SUBJECT: Transmittal of Fort Calhoun Station (FCS) Core Operating Limit Report (COLR) Revision 24

Title: CORE OPERATING LIMIT REPORT

FC-68 Number: EC 27846

Reason for Change: Update to allow for operation in the presence of a Hot Leg flow streaming event.

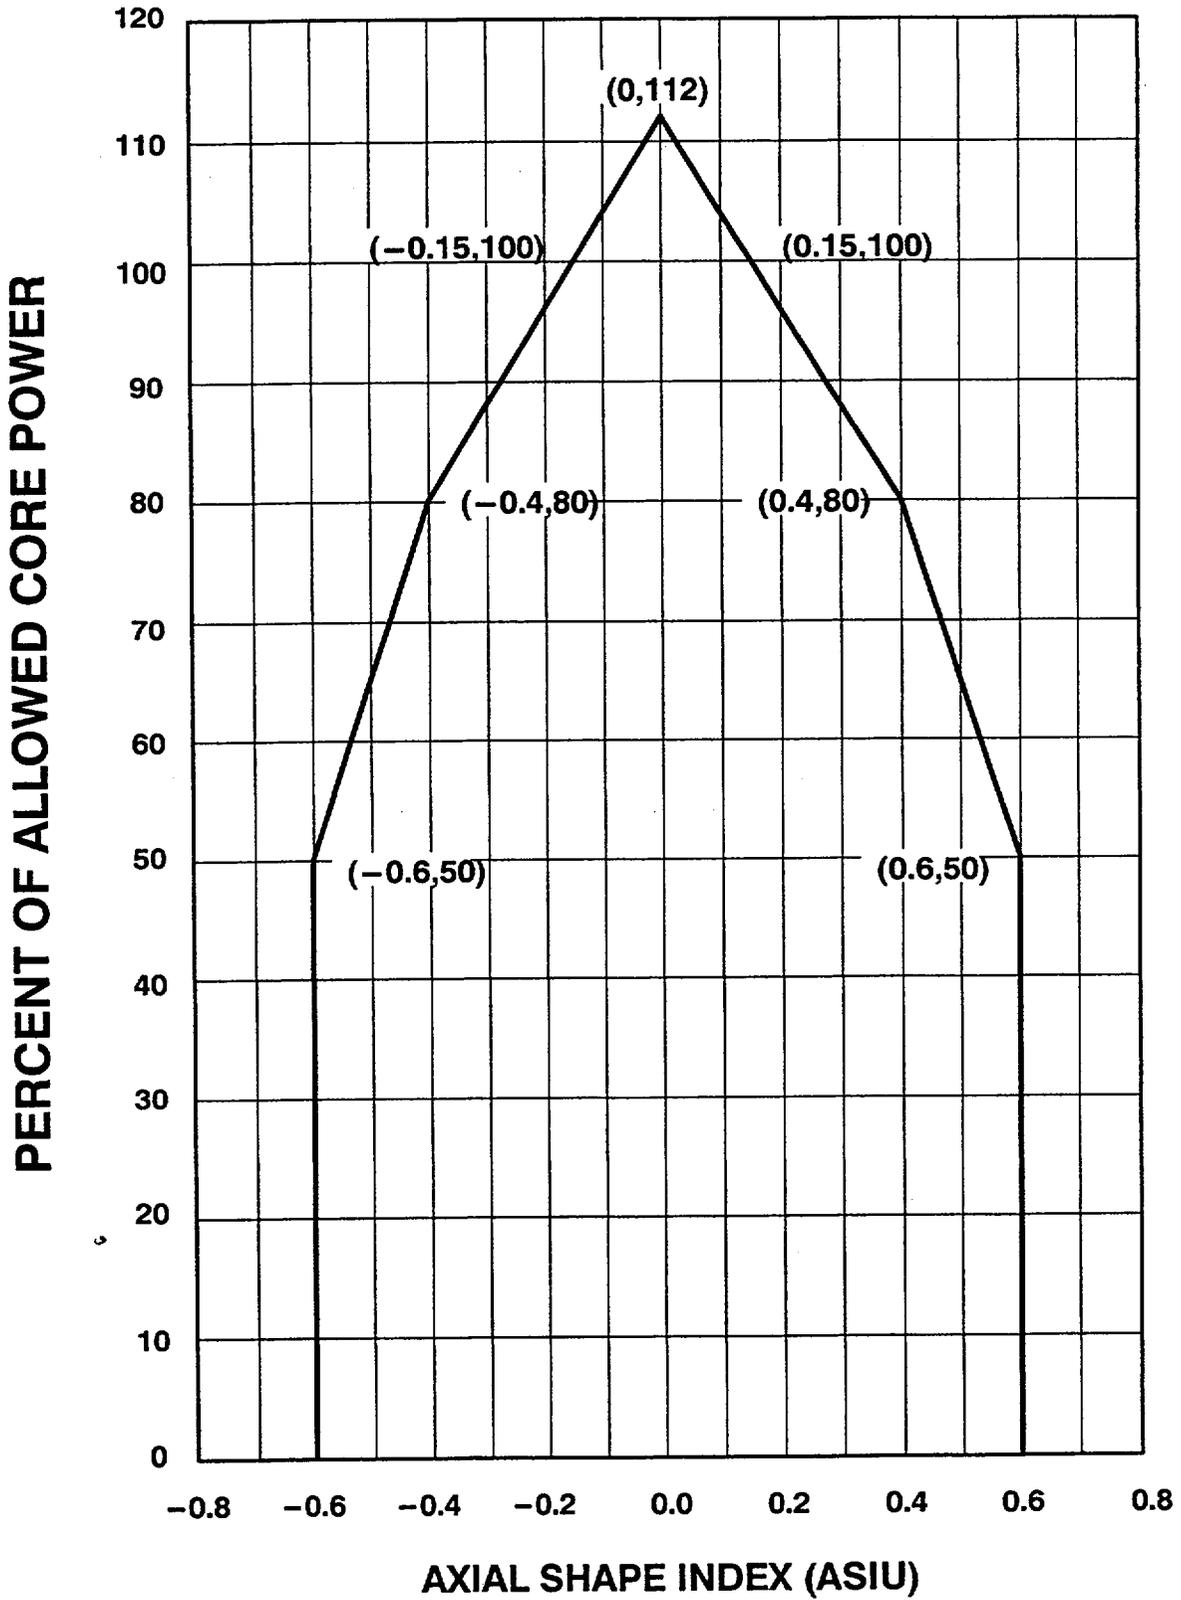
The Cycle 20 maximum full power value for the integrated radial peaking factor (F_R^T) is 1.732. An additional dotted line exists on Figure 7 to allow operation in the presence of a hot leg flow streaming event with less than a 5% power difference between actual power and ΔT power indication.

F_R^T Limit with no hot leg flow streaming event in progress
 F_R^T Limit if a hot leg flow streaming event is in progress with differences between actual power and ΔT power indication of less than 5% power
